ADDENDUM

Date Issued:	September 30, 2025
Project:	Intermountain Health Riverton MRI #2 3741 West 12600 South Riverton, Utah 84065
Addendum Number:	1

Intermountain Health
Riverton Hospital
MRI #2

NJRA Project #
Construction Documents
1 ADDENDUM #01

Floor Plan Level 1

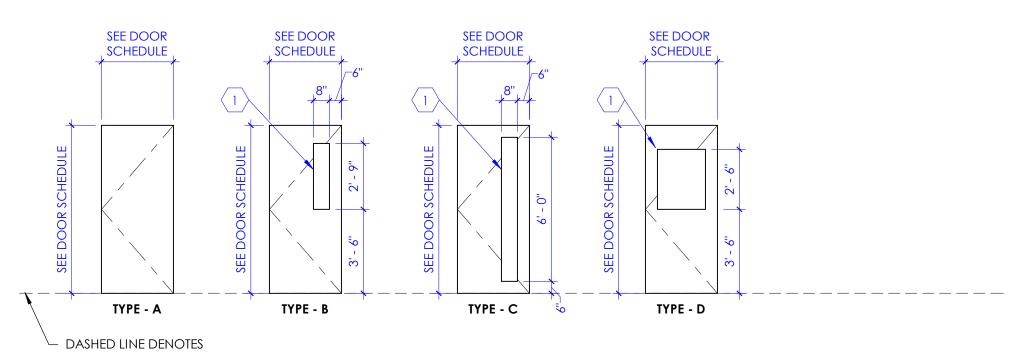
Sheet Number	Drawings		
Architectur	al Drawings		
G002	Update deferred submittal items as indicated.		
G111	Update applicable codes as indicated.		
A113	Update room numbers and keynotes as indicated.		
A601A	Update notes for door schedule as indicated.		
A603A	Update finishes as indicated.

M001

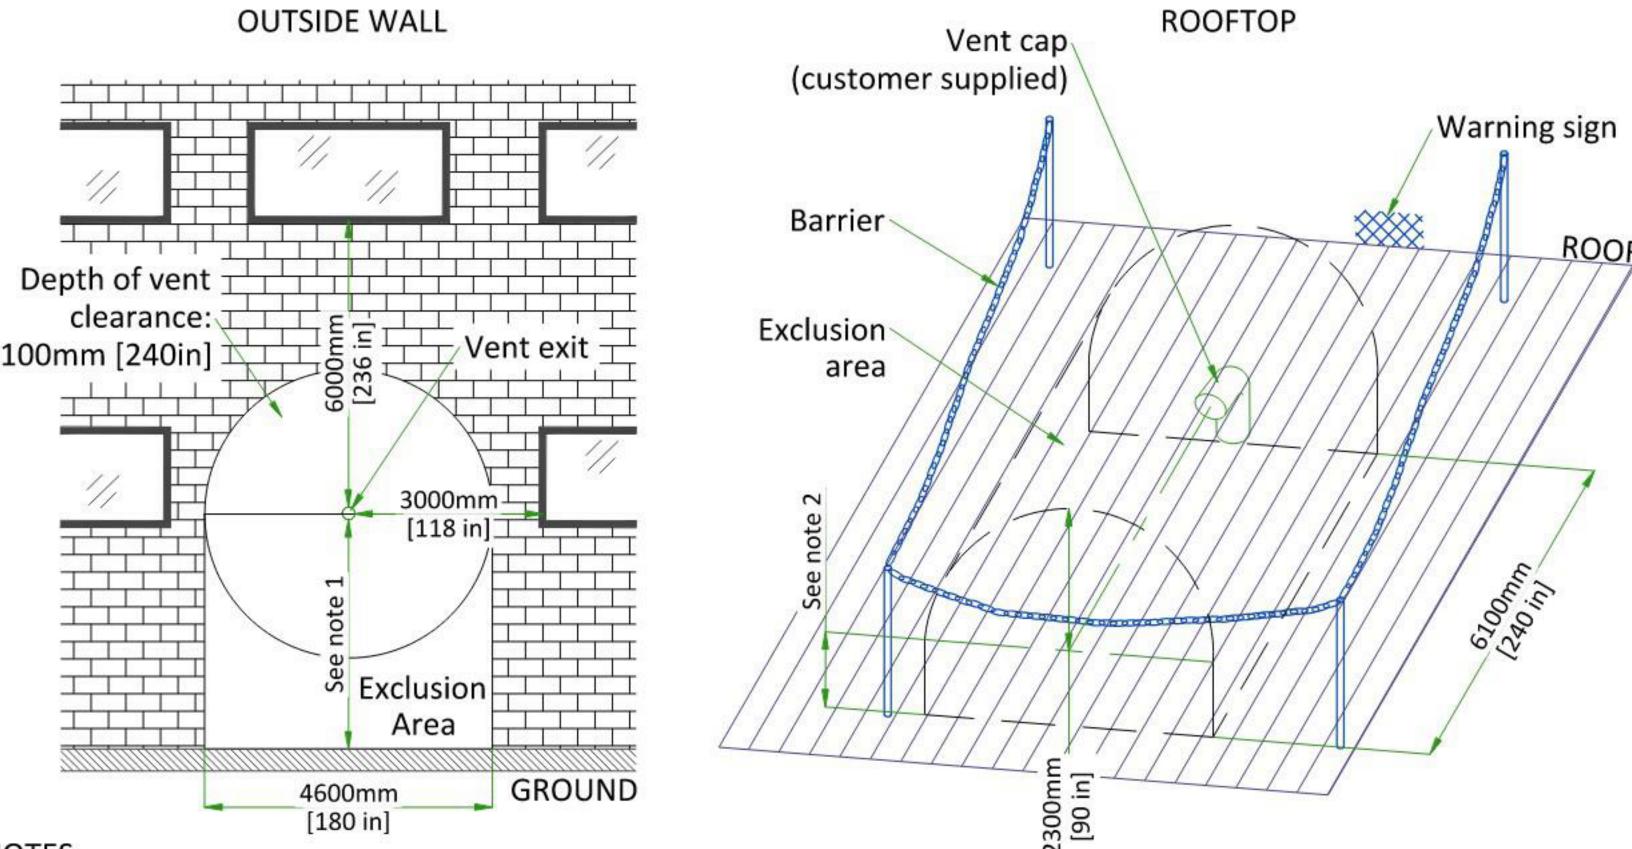
Sheet: M001 - MECHANICAL GENERAL NOTES

EDITED FIRE PROTECTION GENERAL NOTES. UPDATED NOTE #5. ADDED NOTE #7.

LEVEL 1 FIRE PROTECTION PLAN

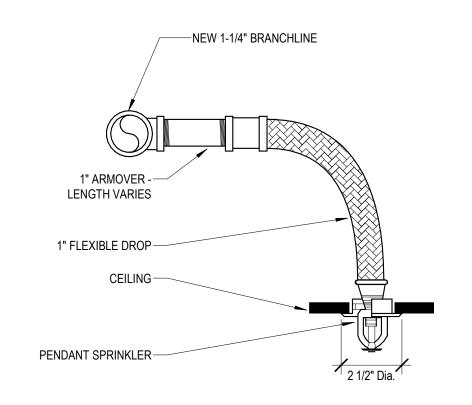
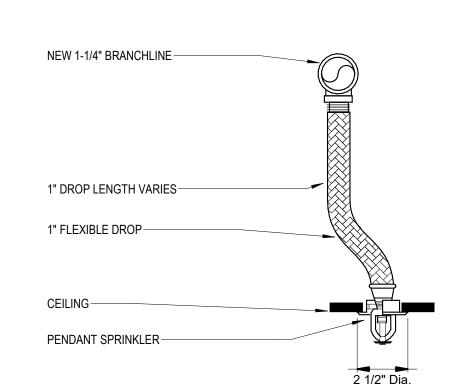
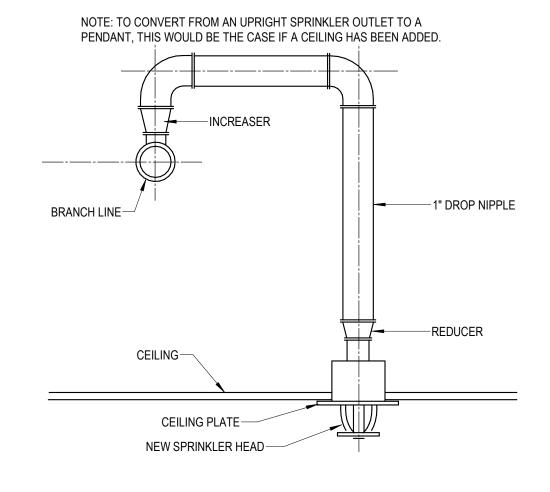
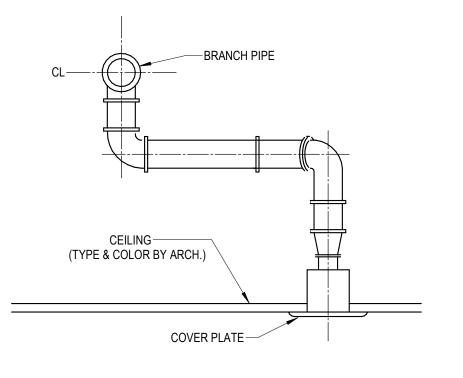
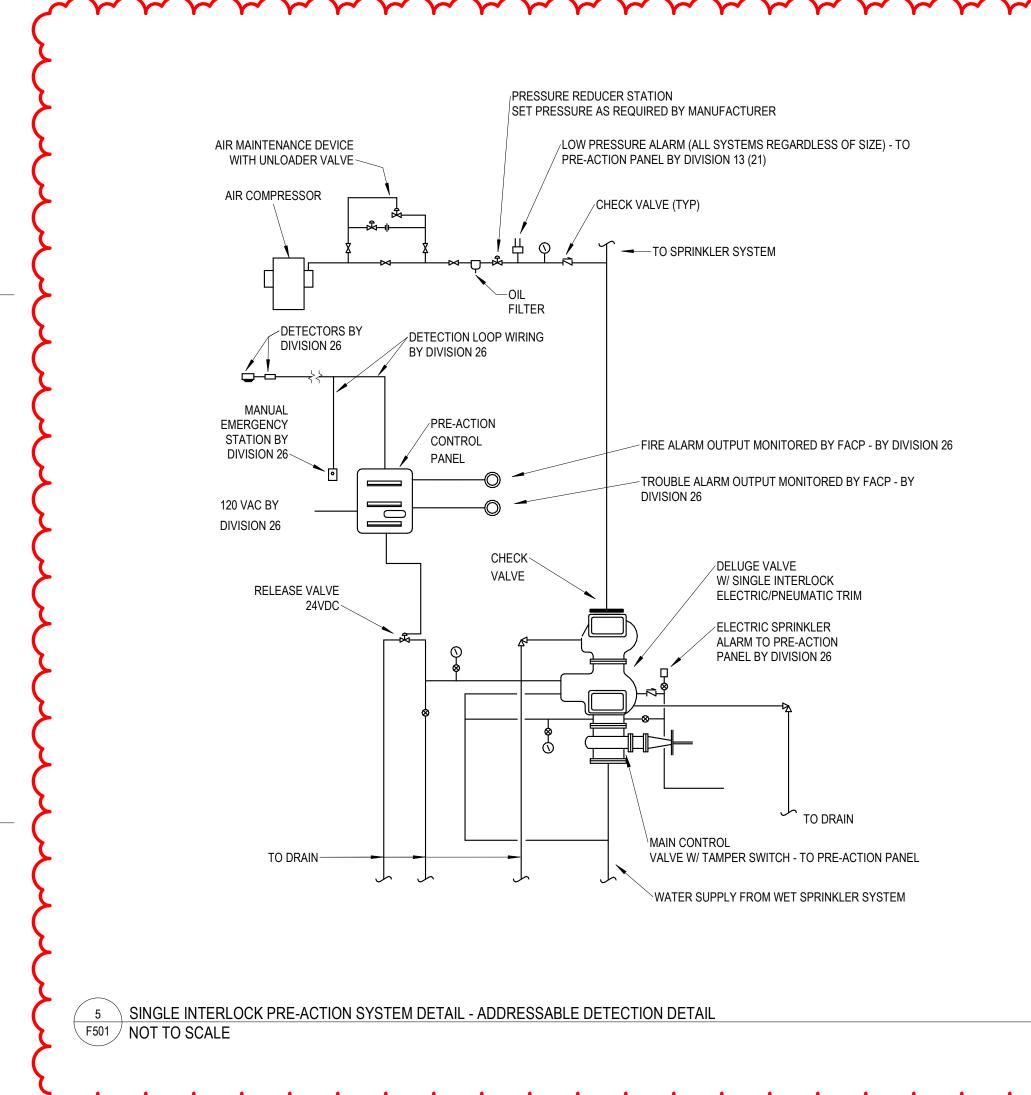
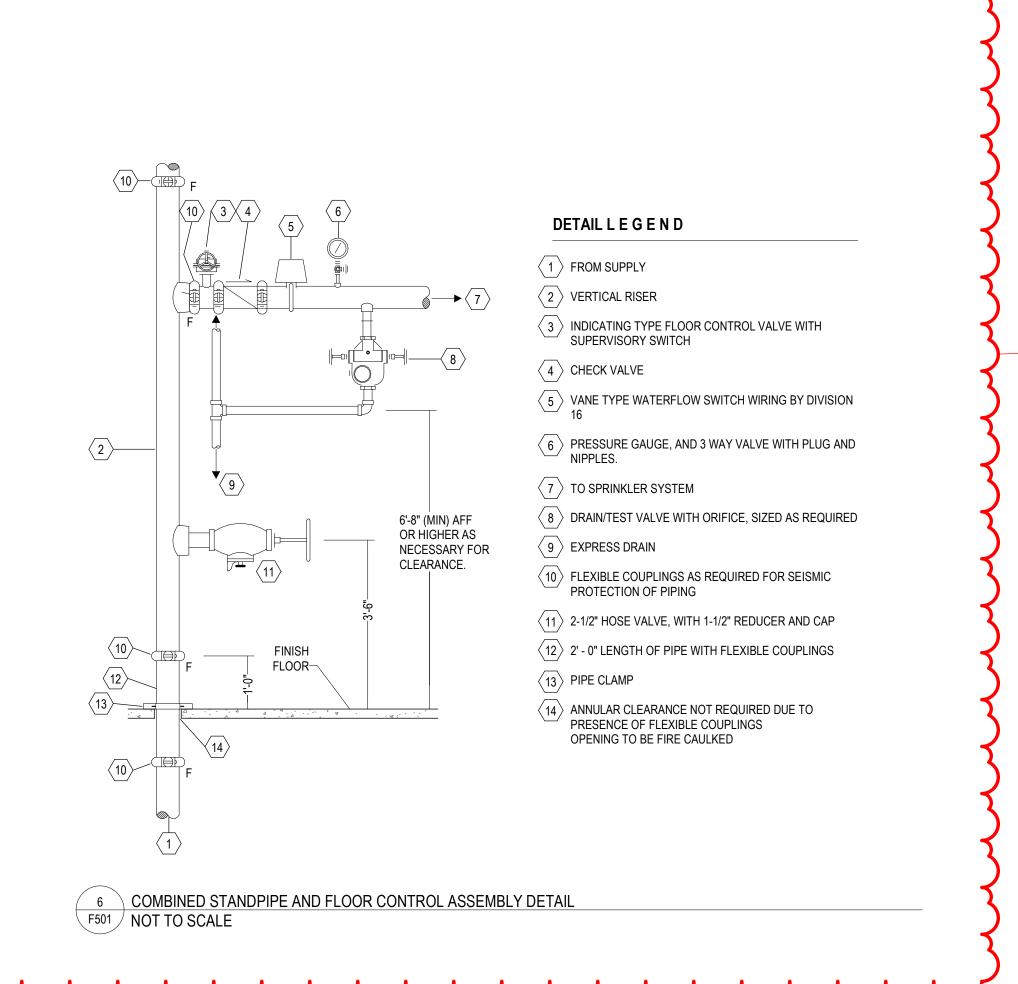
Sheet: F101 - LEVEL 1 FIRE PROTECTION PLAN

- ADDED SYSTEM ABBREVIATION TAGS TO FIRE SPRINKLER PIPES.
- ADDED KEYNOTES #3 AND #4.
